Service Bulletin

Starair Aircraft Co., Ltd.

Document No.: 2023-SA60L-52-01

Subject	Replacement of components of the inner handle of the canopy lock
Category	Important
Applicability	This bulletin applies to the Aurora SA60L series and Aurora SA70L series light sport aircraft listed in Attached Table 1.
Finish Time	Aircraft within the scope of application must be done the work required by this service bulletin completely before July 31, 2024.
Reason	The anti loosening method used for the canopy lock of Aurora SA60L series and Aurora SA70L series aircraft is based on the principle of mechanical linkage over dead center and the method of magnet adsorption. According to feedback from the user, due to vibration or arm contact during flight, the canopy lock may become partially released (the handle lock pin does not come out of the lock hole). To avoid the situation mentioned above, Aircraft within the scope of application are required to replace the handle components of the canopy lock according to the required actions of this bulletin (at their own expense) . First issuance date: October 27, 2023. Effective Date: October 27, 2023 Second issuance date: November 7, 2023

B. The schematic diagrams before and after replacing the inner handle of the canopy lock are as follows.

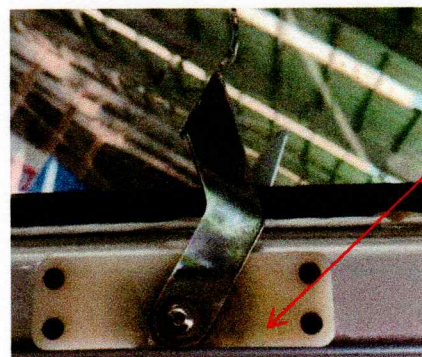
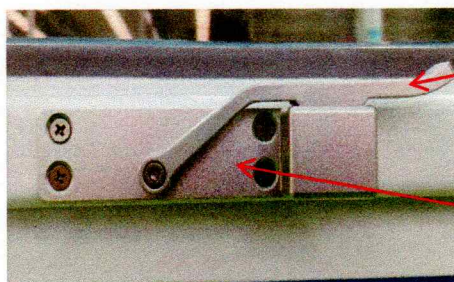
750906000308 magnet with holes14
302990002597 magnet mounting base for Canopy

Type 1 of nylon plate:
316810100005 Left nylon plate
302040000371 Right nylon plate

Before replacing

3168000019 Plate for left inner haddle
3168000018 Plate for right inner haddle

After replacing

1. Removal of the inner handle, plate, and magnet of the old canopy.

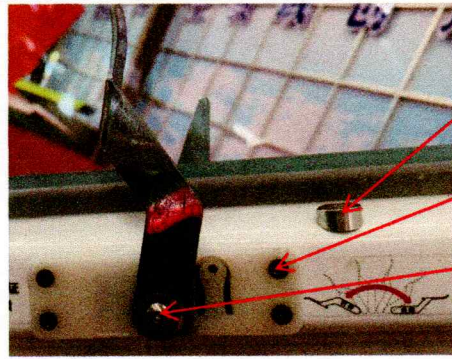
As shown in the following figure, remove mounting screws of the inner handle, nylon plate, and magnet in sequence.

Magnet mounting screw

Nylon plate mounting screw

Inner handle mounting screw

2. Sub assembly of the buckle lock for Left/Right Inner Handle plate. (Complete this step before leaving Starair Aircraft Co.,Ltd.)

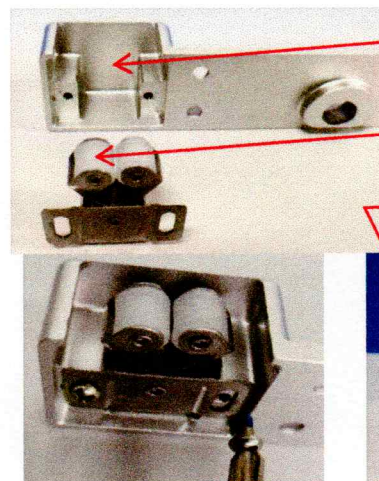
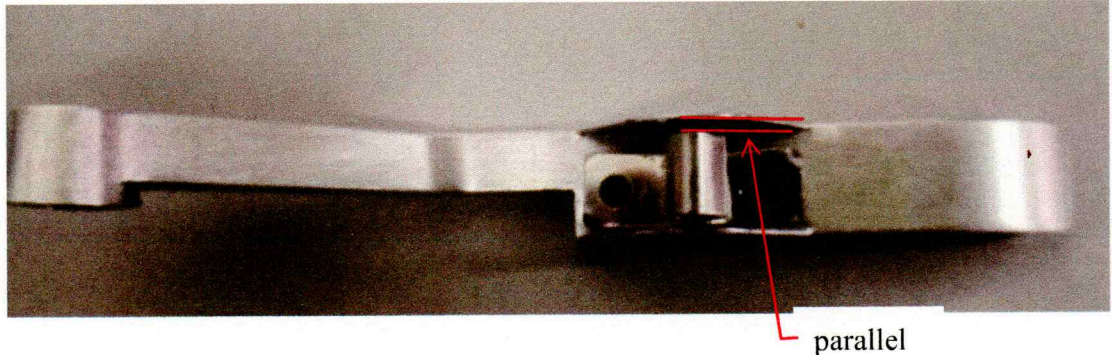
a、 As shown in the following figures. **Between the inner handle cover plate and the latch lock, place two (701501000301 washer 3-A2 GB/T95).** Place the protruding side of the buckle lock inward into the slot of the inner handle plate, screw in **(701323003004 screw M3X8-A2-70 GB/T70.2)**, adjust the buckle lock so that the bottom surface of the buckle lock is tightly attached to the bottom surface of slot of the inner handle plate.

b、 After adjustment, remove **(701323003004 screw M3X8-A2-70 GB/T70.2)**, apply Loctite 243, and tighten it with a cross screwdriver.

c、 Assemble the inner handle on the other side in the same way as above.

Plate slot

The protruding face of the buckle lock

The bottom surface of the buckle lock is tightly attached

4. Installation of left/right inner handle plate.

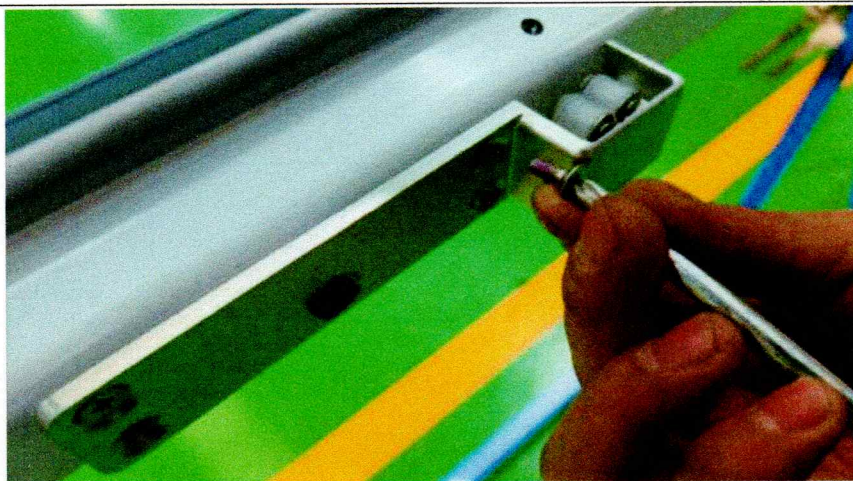
As shown in the following figure, insert the camshaft into the hole of the inner handle plate, align the installation hole of the inner handle with the fixing hole of the canopy, and screw (701312004210 countersunk head tapping screw ST4.2X13 GB/T 846) into the installation hole of the inner handle plate. If the thread inside the canopy frame slides during disassembly, use a hand electrical drill to enlarge the diameter of the countersunk holes of (3168000019 left inner handle plate) and (3168000018 right inner handle plate) to D5, and then screw (7110000805 countersunk head tapping screw ST4.8X12 GB/T846) into the installation hole of the inner handle plate. Tighten it with a cross screwdriver.

5. Installation of the Left/Right Inner Handle .

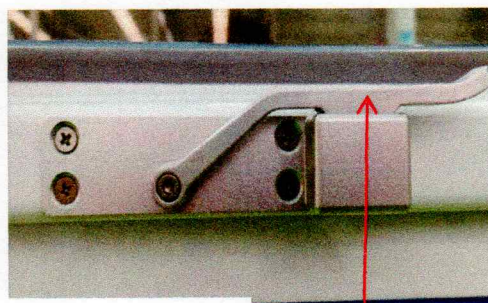
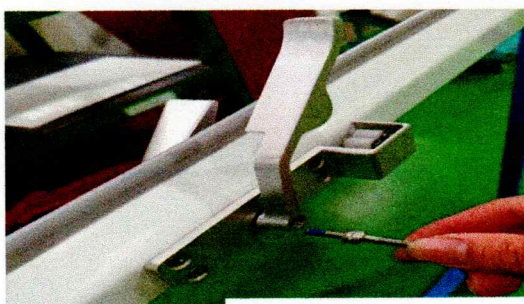
a、As shown in the following figures, align the direction of the inner handle and outer handle of the canopy. Insert the waist-shaped groove into the gap of the camshaft, apply Loctite 243, and then screw in (701302005068 screw M5X12-A2-70 GB/T 70.1). Tighten it with a 4mm hex socket wrench, with a torque of 3.8Nm

b、Pull the inner handle backwards to the limit position, confirm that the buckle of the inner handle can be fully engaged and locked inside the buckle lock, and ensure that there is no interference between the inner and outer handles and the canopy frame when the canopy is locked and unlocked.

The buckle of the inner handle be fully engaged and locked inside the buckle lock
